W31: IH-10 Boerne Stage to Old Fredericksburg Sanitary Sewer

Job No.: 09-2502

ADDENDUM 2

October 4, 2016

SHEET NUMBER: C-46
SHEET 99 OF 135

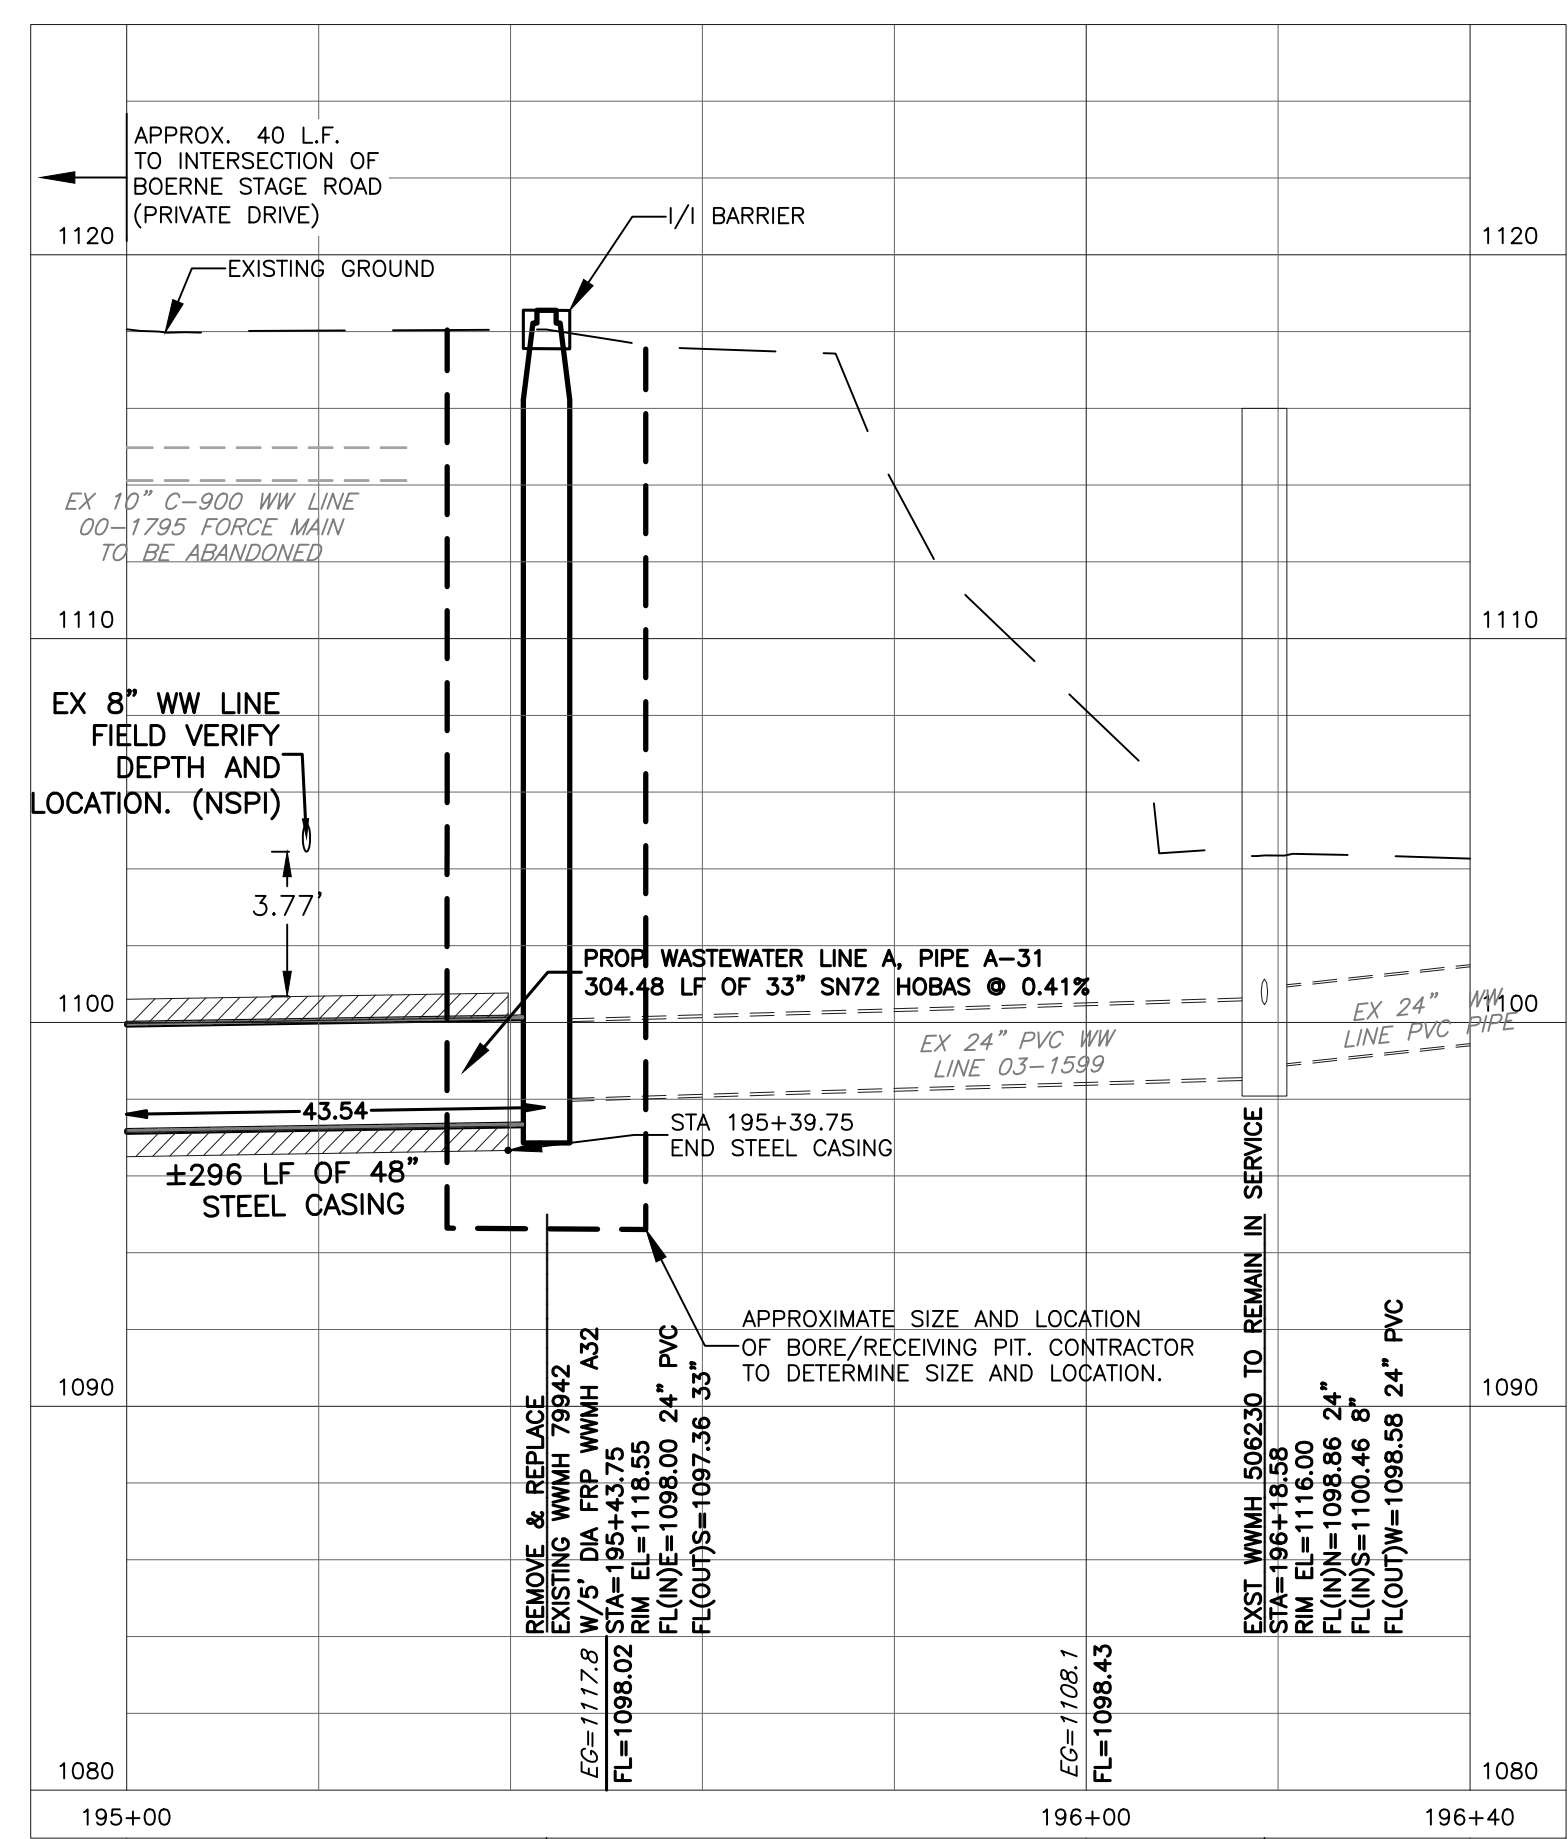
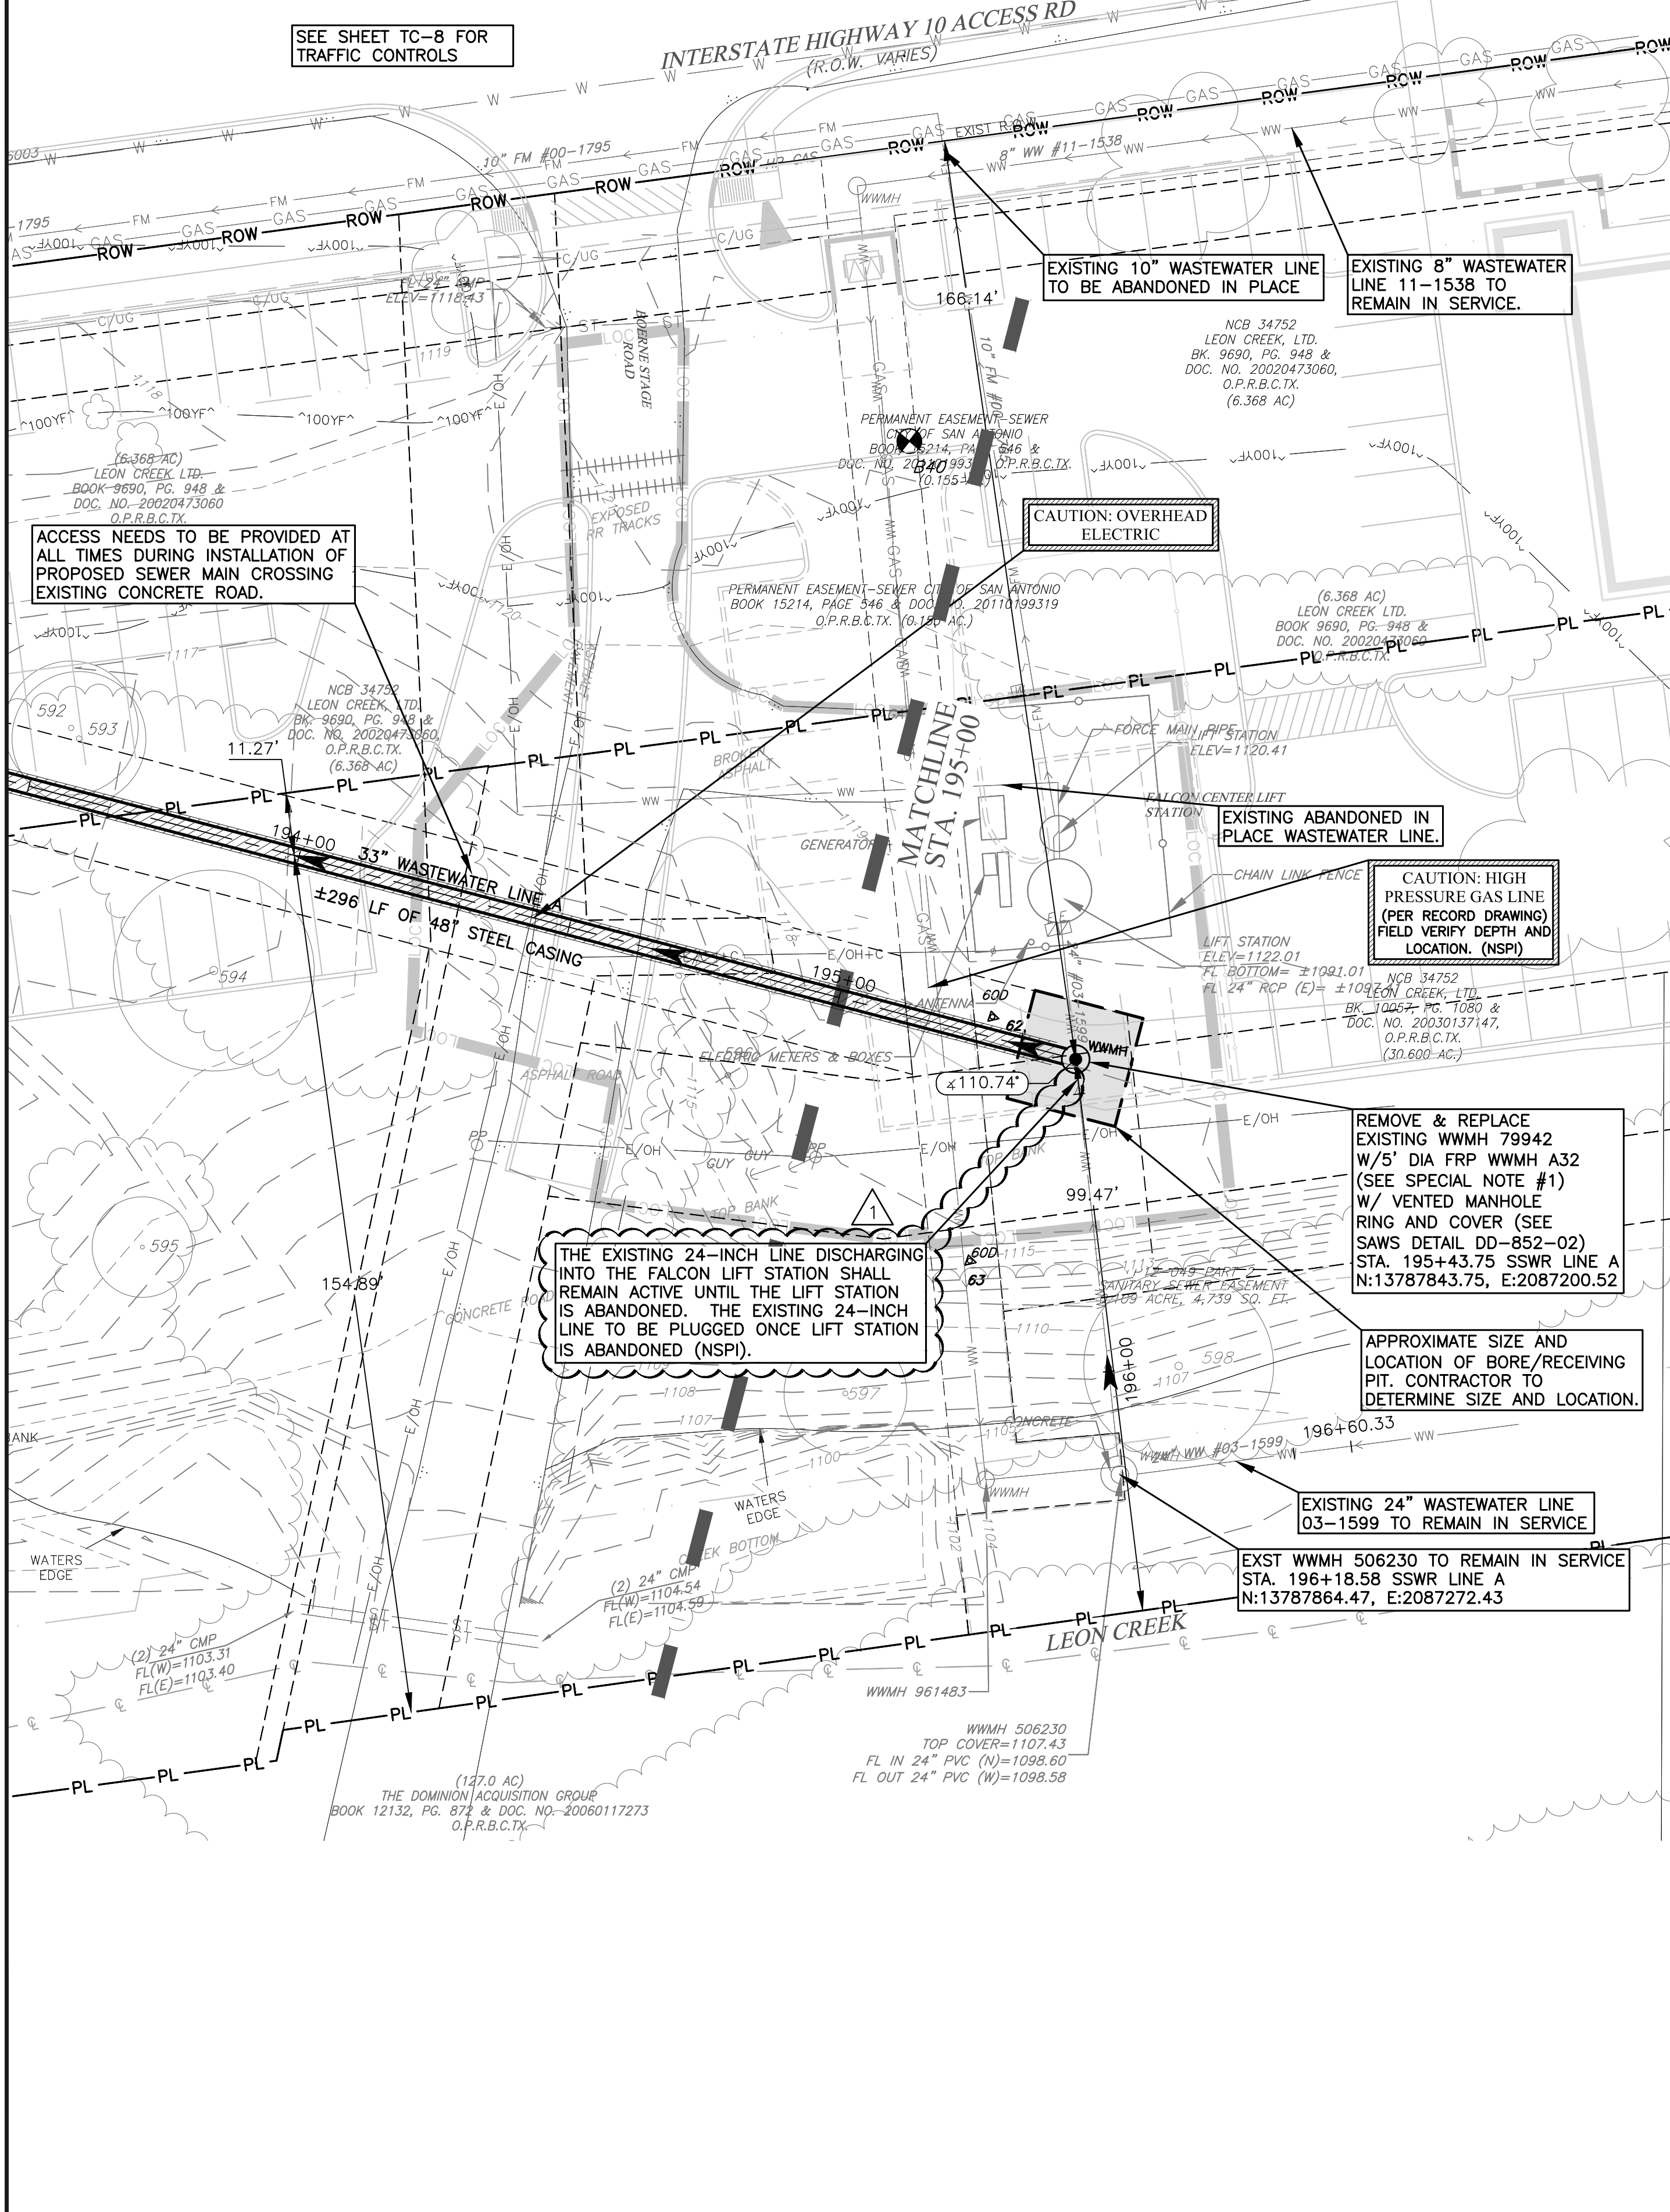
3. The following note was added to Sheets C-9, C-10, C-12, C-13, C-14, C-15, C-45, and C-46:

"The Contractor shall provide the property owner a written notice of initial entry 10 days prior to start construction within their property."

6. On Sheet C-46, the following note was added:

“The existing 24-inch line discharging into the Falcon Lift Station shall remain active until the lift station is abandoned. The existing 24-inch line to be plugged once lift station is abandoned (NSPI).”

- SPECIAL NOTES:**
- THE REMOVAL AND DISPOSAL OF EXISTING MANHOLE #79942 WILL BE INCIDENTAL TO THE INSTALLATION OF PROPOSED MANHOLE A32. THERE WILL BE NO SEPARATE PAY ITEM FOR ITS REMOVAL.
 - THE CONTRACTOR SHALL SUPPORT OR BRACE POWER POLES IN THIS AREA AS NEEDED (NSPI).
 - THE CONTRACTOR SHALL PROVIDE THE PROPERTY OWNER A WRITTEN NOTICE OF INITIAL ENTRY 10 DAYS PRIOR TO START CONSTRUCTION WITHIN THEIR PROPERTY.

A TEE-BASE FIBERGLASS MANHOLE DETAIL
NOT TO SCALE

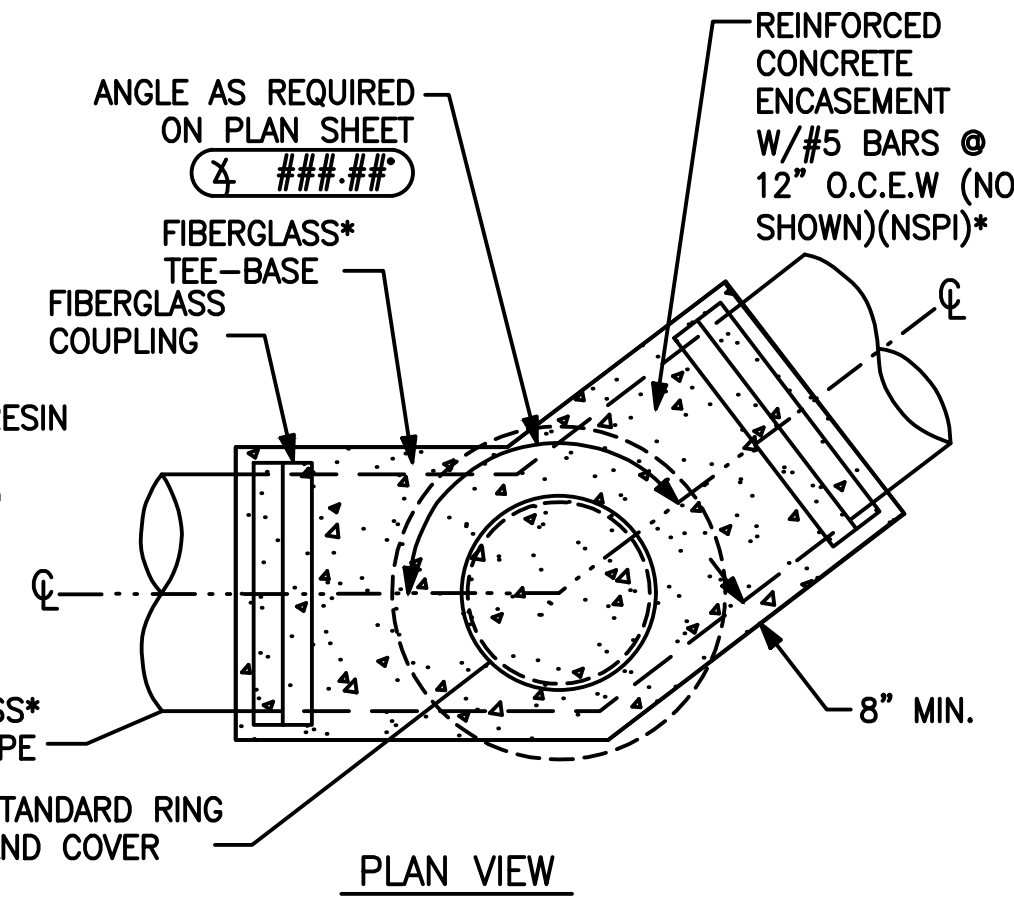
8. On Sheet C-48, the note about grouting annular space has been removed and the MH opening has been changed from 36” to 30”.
